11 EAST KIRKE STREET, CHEV CHASE
CHEV CHASE VILLAGE HISTORIC DISTRICT

SUBJECT: Historic Area Work Permit #467285, window replacement

MONTGOMERY COUNTY HISTORIC PRESERVATION COMMISSION
STAFF REPORT

Address:	11 East Kirke St, Chevy Chase	Meeting Date:	10/24/2007
Resource:	Non-Contributing Resource Chevy Chase Village Historic District	Report Date:	10/17/2007
Applicant:	Gina and Arch Campbell	Public Notice:	10/10/2007
Review:	HAWP	Tax Credit:	None
Case Number:	35/013-07II	Staff:	Joshua Silver
PROPOSAL:	Window replacement

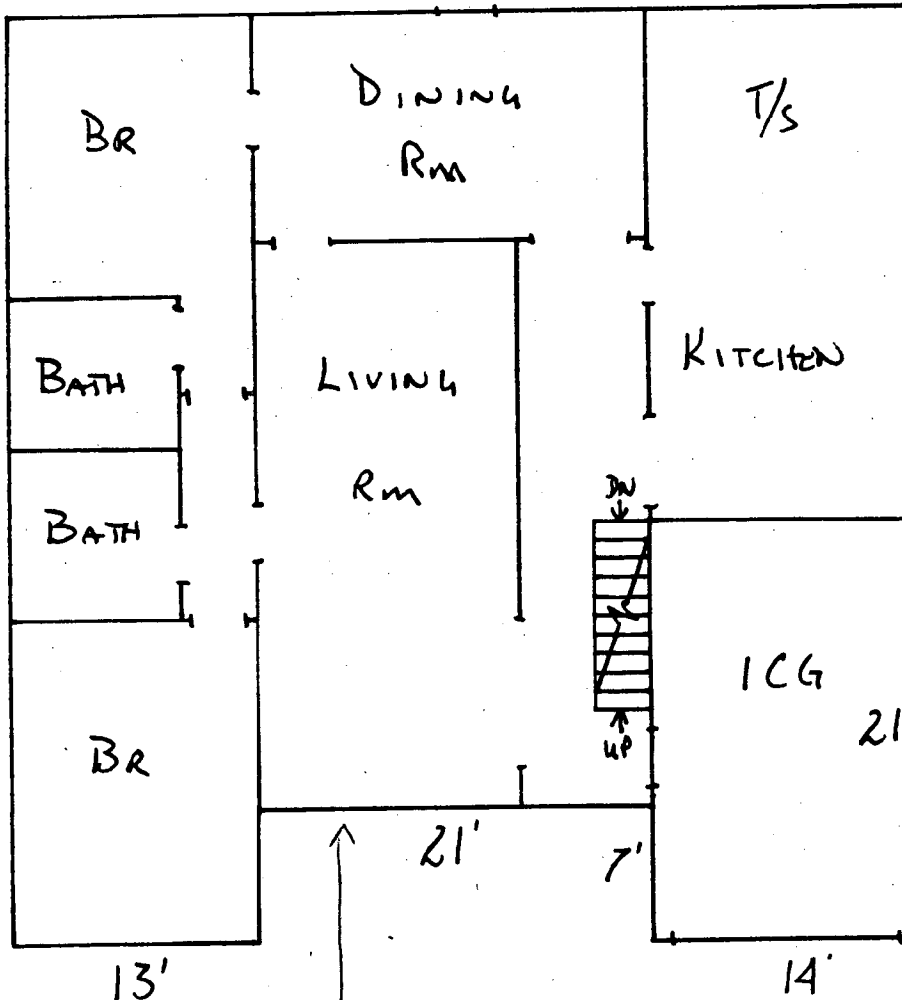
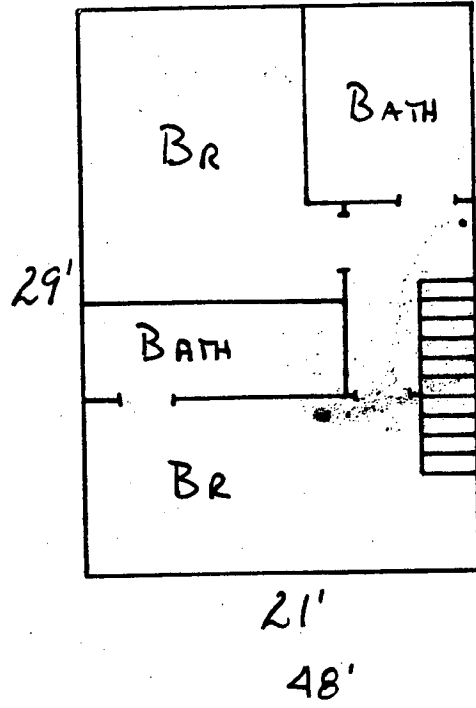
Windows in these
bathrooms
49'
each window
measures
34 inches x
23 inches

basement windows below grade here

each window measures
30 inches x 22 inches

glass in these windows to be tempered & obscurved
